## Staff Report to the Zoning Administrator

Application Number: **04-0664**

**Project Description:** Proposal to construct a two-story structure with an office and garage on the lower floor and a residence (studio apartment) on the upper floor. Requires a Variance to reduce the front yard setback from Marina Avenue from 20 feet to 0 feet, and a reduction of the front yard setback from Venetian Road from 20 feet to about 16 feet.

**Location:** 115 Venetian Road, Rio Del Mar

Fig 1. View of lot at Venetian Road

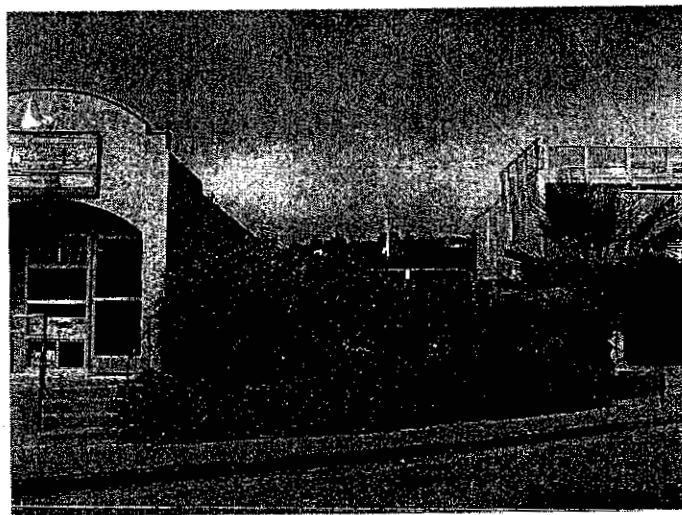
A variance is requested to allow the garage with a deck above to extend to the property line along Marina Avenue and into the front setback. The project is located in the C-1 zone district. Since the site has two street frontages the required front setback on both Venetian Road and Marina Avenue would be ten feet on each, however because the site has residential zoning across both streets, the operative setback would be twenty feet.

Staff supports the variance due to the unusually small size of this lot (1,760 sq. ft.) as well as the narrow width (less than 30 ft.). This small lot has two street frontages and applying the front setbacks from each street severely limits the developable area. A building built to the setback would have a footprint of approximately 700 sq. ft. maximum. The adjacent lots are similarly zoned and built to the front setback (see Fig. 2).
